**Stage 1
Road Safety Audit**

Neo Environmental Limited

**Drybridge Solar Farm
and BESS**

No Road Markings or Signage Provided
(Drawing No. NEO01191_054I_A Figure 5.2)

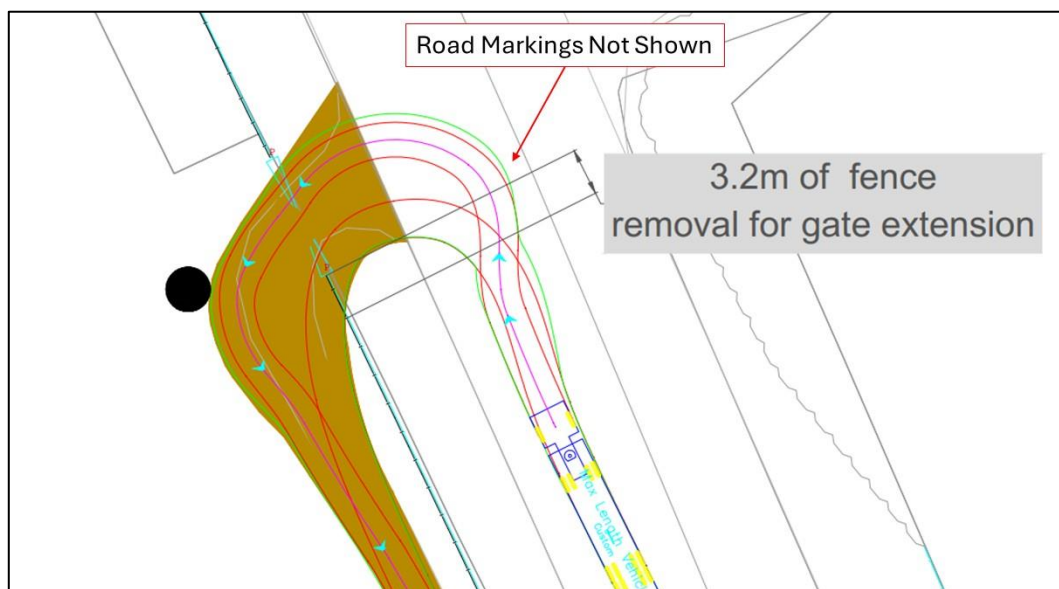
The proposed junction layouts for the permanent access arrangements, at both Site Access 1 and Site Access 2 have not been submitted. The drawing provided does not include the full access design details typically associated with a standard Roads Layout drawing, including road markings, signage, and other permanent traffic control measures.

In the absence of appropriate road signage and markings, there is potential for driver uncertainty in relation to permitted access and egress manoeuvres, which could result in vehicle conflict and collision.

Detailed permanent access junction layouts (at both Site Access 1 and Site Access 2) should be provided for the operational stage of the development, when maintenance personnel will require regular access to the site.

Existing R132 Road Carriageway including a Solid Hatched Median (Google Image)

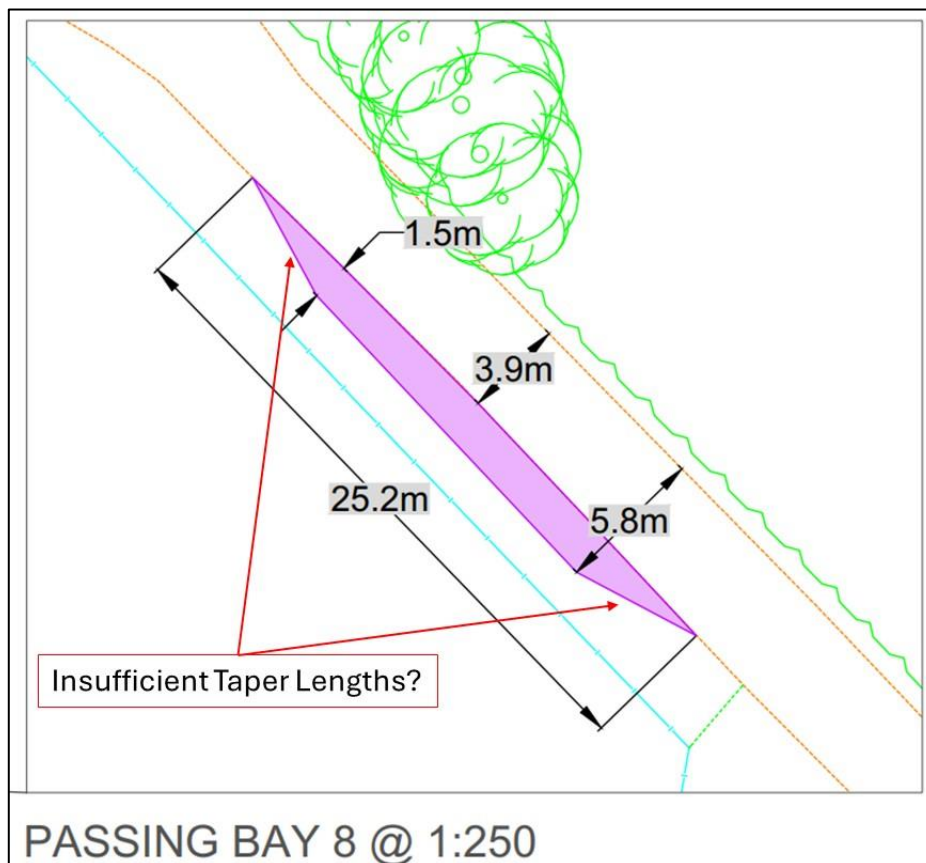
It is proposed that HGVs will egress from Site Access 1 via a left-turn manoeuvre only. However, no details have been provided to demonstrate how the prohibition of right-turn movements will be effectively enforced. Given the presence of an extensive solid hatched median along much of the R132, motorists would not reasonably anticipate right-turning movements emerging from a side road, with the risk of a collision.

Measures to prohibit HGVs from undertaking right-turn movements upon exit from the site should be clearly set out and detailed.

Passing Bay Taper Lengths (Drawing No. NEO01191_071I_B Figure 5.6)

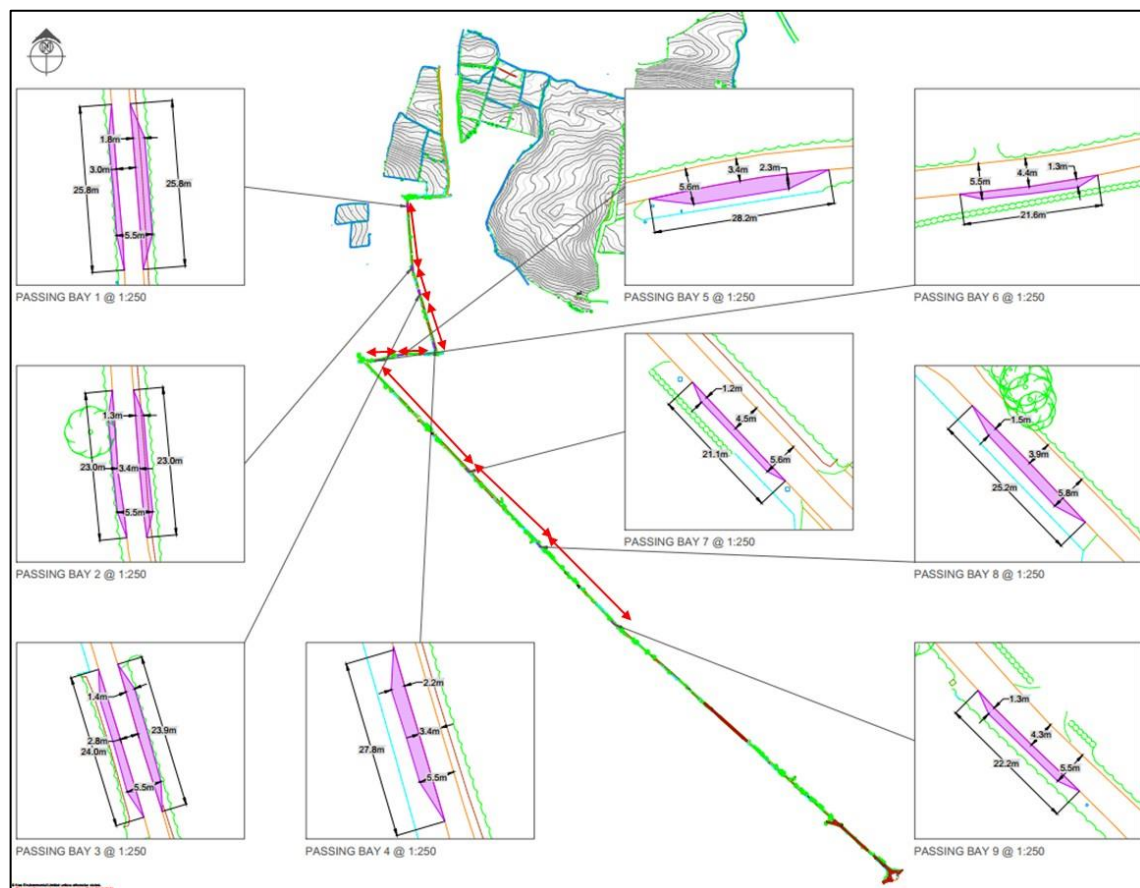
The proposed entry and exit transitional taper lengths to the passing bay appear to be insufficient. Inadequate taper provision may result in abrupt lateral vehicle movements when entering and exiting the passing bay, leading to sharp weaving manoeuvres. This could increase the likelihood of vehicles encroaching into the opposing carriageway, particularly on exit from the passing bay, thereby resulting in a side-swipe or head-on collision.

Appropriate Taper Lengths should be provided at the Passing Bays.

L6322 / LT6322 Priority Junction (Google Image)

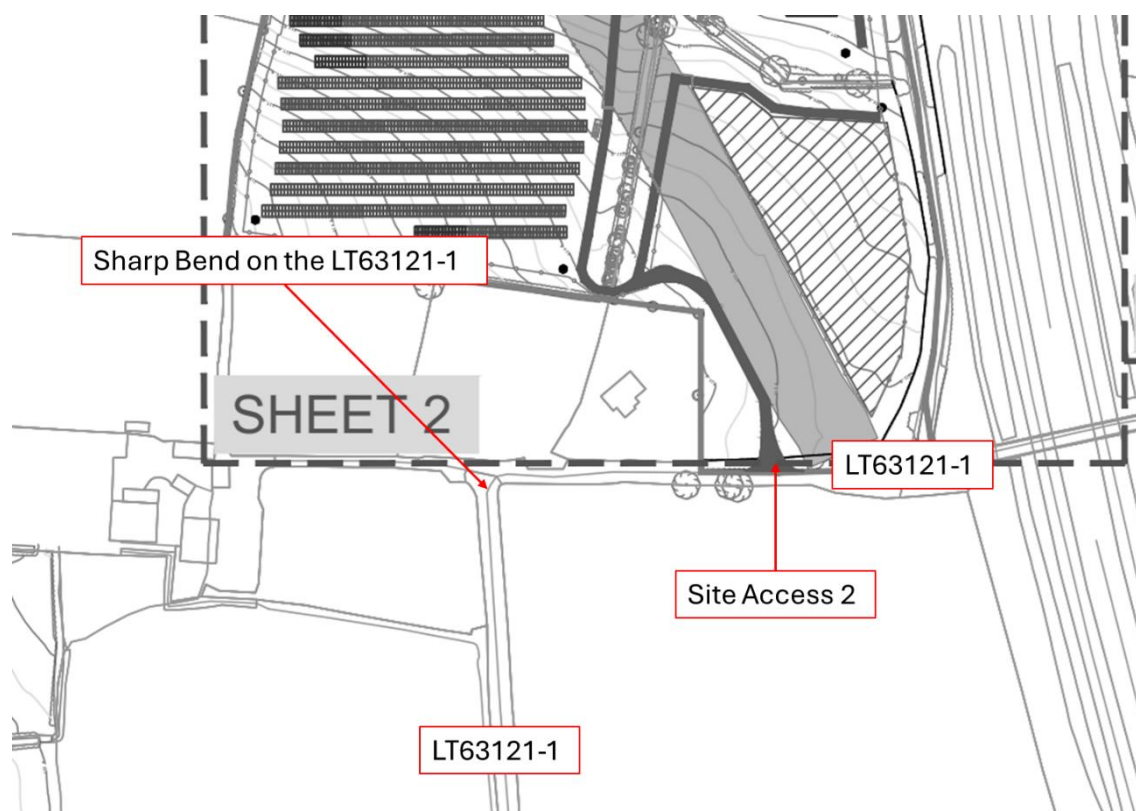
There is a very sharp turn at the junction of the L6322 and LT6322, with a slight skew in the angle at which it meets the L6322 mainline. The tracking drawings show a 16.5m articulated vehicle accessing the development. It is not clear if such a vehicle would be able to turn into and from this junction without significantly overrunning the opposing lane or into the verge, which could result in a collision.

Swept path analysis should be undertaken for this junction to demonstrate that the proposed 16.5m articulated vehicles can safely negotiate the turn without encroachment into verges.

Should the analysis identify that the manoeuvre cannot be accommodated safely within the existing geometry, smaller delivery vehicles or implementing appropriate traffic management measures during delivery times may be required.
